Klippon® Relay

Product discontinuation note

RIDERSERIES RCL

RIDERSERIES RCL successor - CUBESERIES CRI relay modules
The RIDERSERIES RCL relays and KITs will be discontinued and replaced by our new CUBESERIES CRI relays and KITs.

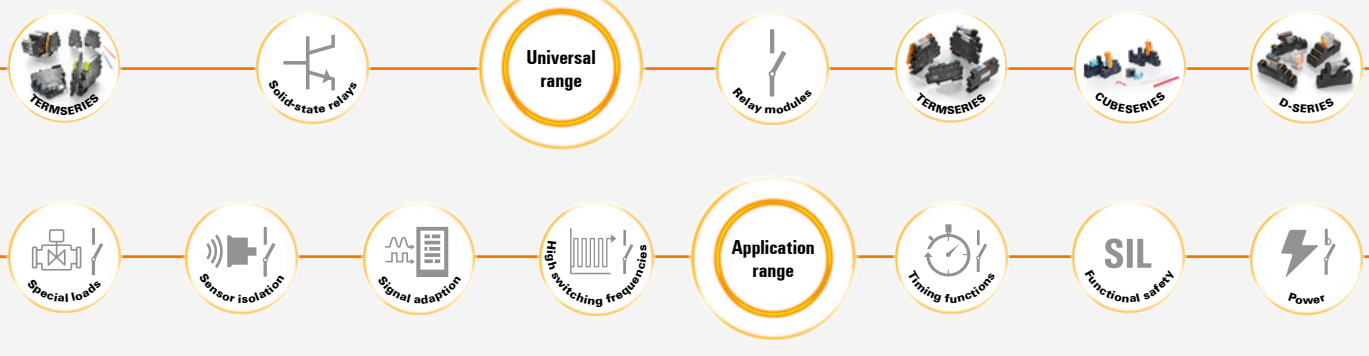
Important note: The respective accessories (relay sockets, retaining clips, LED modules, markers, etc.) of the RIDERSERIES RCL relays are not compatible with the alternatively offered products of the CUBESERIES CRI. Therefore, the accessories must also be switched to the CUBESERIES CRI. The alternatives listed are the closest possible successors to the discontinued products. Major differences are described in the comments for the new product. However, the suitability of the successor must be thoroughly reviewed, as the products are not absolutely identical.

The CUBESERIES CRI miniature industrial relays with a space-saving width of 16 mm for reliable switching of small industrial loads and fast and secure installation.

- 1 CO contact (16 A) and 2 CO contacts (8 A)
- Versions with and without test button
- Coloured test buttons or housings (AC coil: orange, DC coil: blue)
- Matching accessories such as cross-connections, retaining clips and LED modules
- Pluggable LED modules with red and green status LED
- Relay sockets available with PUSH IN or screw connection
